Ducted Systems Technical Services Service Tips Letter

Letter: **ST-005-2019**

Subject: **Incorrect Low Voltage Outdoor ECM Fan Motor Module Wiring.**

Product: **Residential Heat Pump Product Models: YHE, and RHP14L 3 Ton models only**

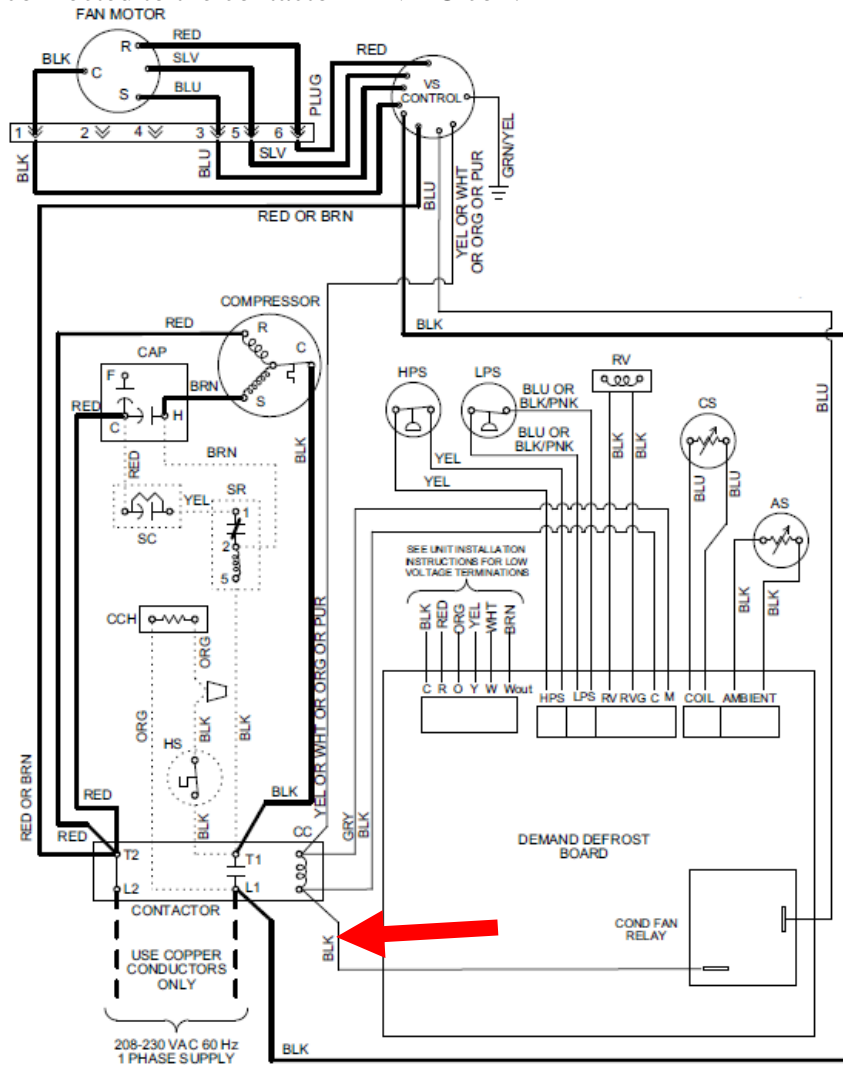
We have received a small amount of calls concerning the outdoor ECM fan motor module low voltage wiring, being wired incorrectly to the high voltage leg of the contactor. When wired this way, the contactor will send 120 VAC to the 24 VAC input of the ECM module. Below you will find the wiring schematic showing the Generation 1 model units with PSC motors.

Implemented in August 2018, only the generation 2 YHE and RHP14L models were built with a true ECM motor, module, and wiring. Below is a wiring schematic showing where the ECM module's low voltage black wire is to be connected to the contactor 24 VAC coil.
